**Serial ATA  
International Organization**

**Version 0  
June 14, 2007**

**Serial ATA Revision 2.6 ECN # 018  
Title : Figure 69 Pin Location Correction**

### 2.1 Figure 69 in Section 6.3.4.1.2 Slimline Power cable receptacle connector

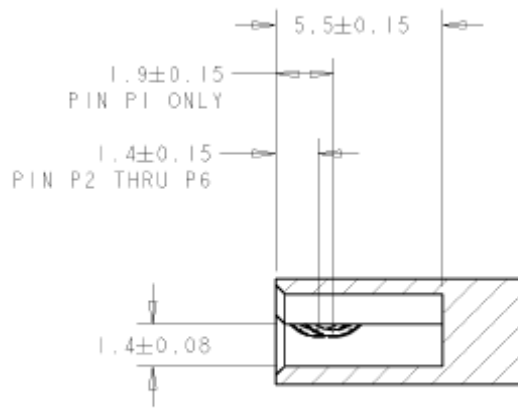
Figure 69 erroneously shows Pin 1 and P2 through Pin 6 locations. Does not agree with Figure 75.

The locations of the pins are incorrect. Figure 69 must change to correct it.

The incorrect locations will result in improper sequencing of contact mating for any connector built to them.

Change Section A-A in Figure 69 to the following:

Note that the difference is in which contact is shown on top and the location of Pin P1 only contact was changed from  $1.4 \pm 0.25$  to  $1.9 \pm 0.15$  and the location of Pin P2 thru P6 was changed from  $1.9 \pm 0.25$  to  $1.4 \pm 0.15$ .
